ACCESSION NBR: 9503010299 DOC. DATE: 95/02/22 NOTARIZED: NO DOCKET #
 FACIL: 50-269 Oconee Nuclear Station, Unit 1, Duke Power Co. 05000269
 50-270 Oconee Nuclear Station, Unit 2, Duke Power Co. 05000270
 50-287 Oconee Nuclear Station, Unit 3, Duke Power Co. 05000287

SUBJECT: Submits response to NRC questions on proposed mod to plant emergency electrical sys.

Subject: Oconee Nuclear Station
Docket Nos. 50-269, -270, -287
Response to NRC questions on Technical
Specification 4.6 Revision

PRE-MODIFICATION
KEOWEE/EPSSL SEQUENCE OF EVENTS FOR NON-LOAD REJECTION SCENARIO
KEOWEE UNITS NOT PREVIOUSLY ONLINE @ T=0

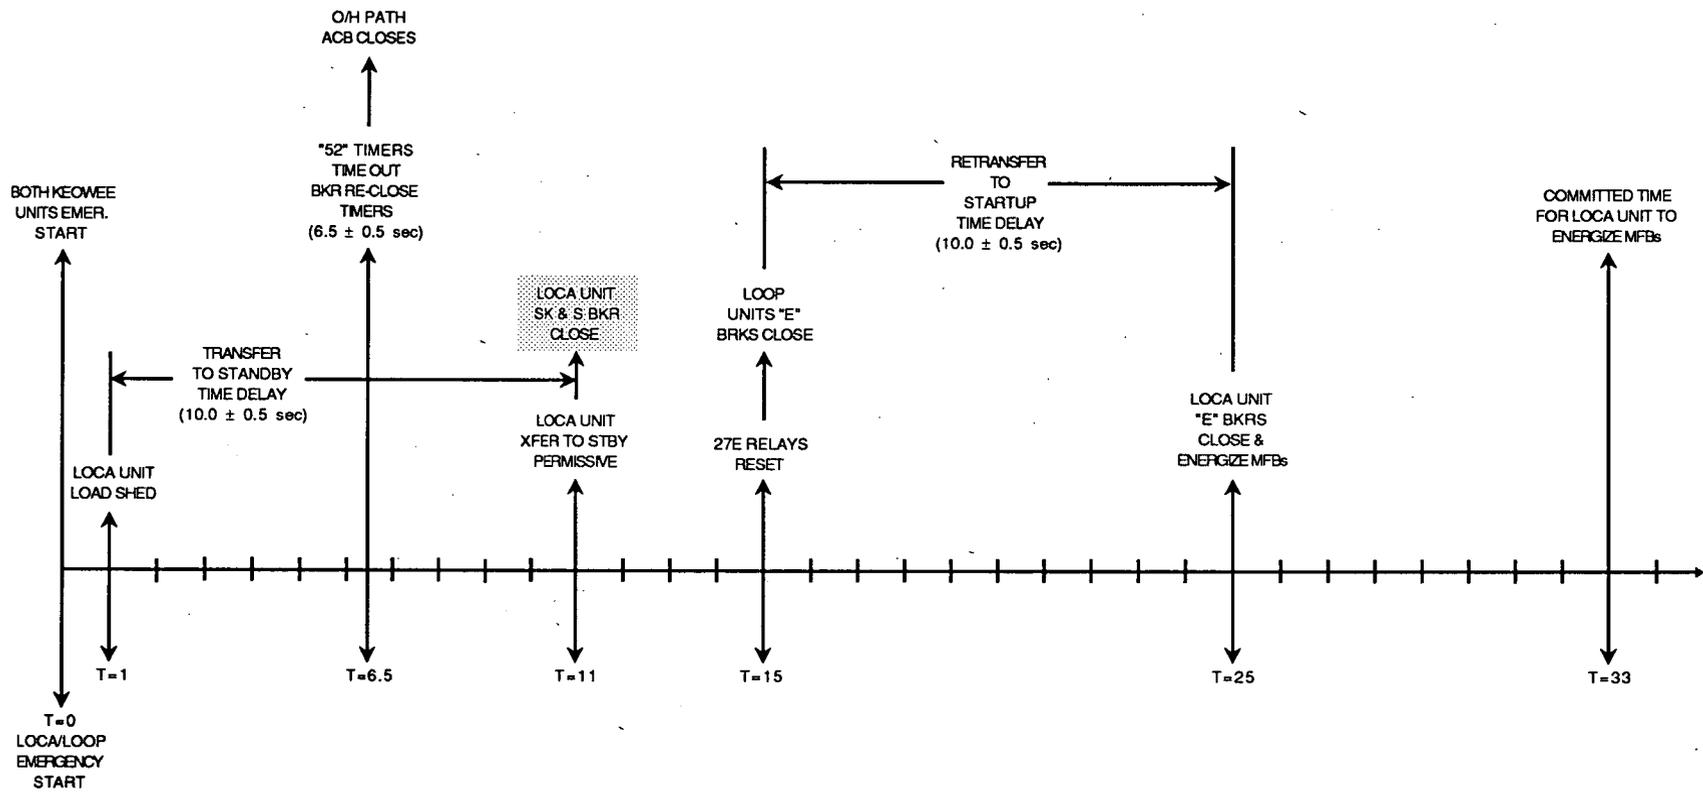
LER 93-01 references FSAR Section 15.14.3.3.6 as containing the requirements that ECCS flow be established within 48 seconds for the LOCA/LOOP scenario. Please provide a detailed discussion (using detailed timelines) of the sequence of events for worse case load rejection/overfrequency scenario which includes the worst case values (considering uncertainties) for undervoltage relay reset, frequency relay setpoints (pickup and reset) and associated time delays, breaker closure times, retransfer startup time delays, etc. Compare this to the worst case sequence for a non-overfrequency scenario to provide the basis for margin between the current FSAR analyses and a worse case load rejection scenario. Discuss any modifications and/or administrative controls that have been or will be implemented that ensure the analysis of FSAR Section 15.14.3.3.6 remains bounding.

The 48 second requirement that is listed in FSAR Section 15.14.3.3.6 can be described in two separate steps. The first part is the Keowee/EPST time and the second part is the MOV stroke time. FSAR Section 6 describes the MOV stroke time as being 15 seconds. This 15 second allowance also bounds the start times for the Engineered Safeguards pumps. Thus, the Keowee/EPST function must be performed within 33 seconds. Attachments 4-1, 4-2, 4-3 and 4-4 show the timelines for non-load rejection and load rejection scenarios. Tolerances are included in these figures to quantify the worst case response time. Also, these timelines indicate the pre-modification and post modification configurations.
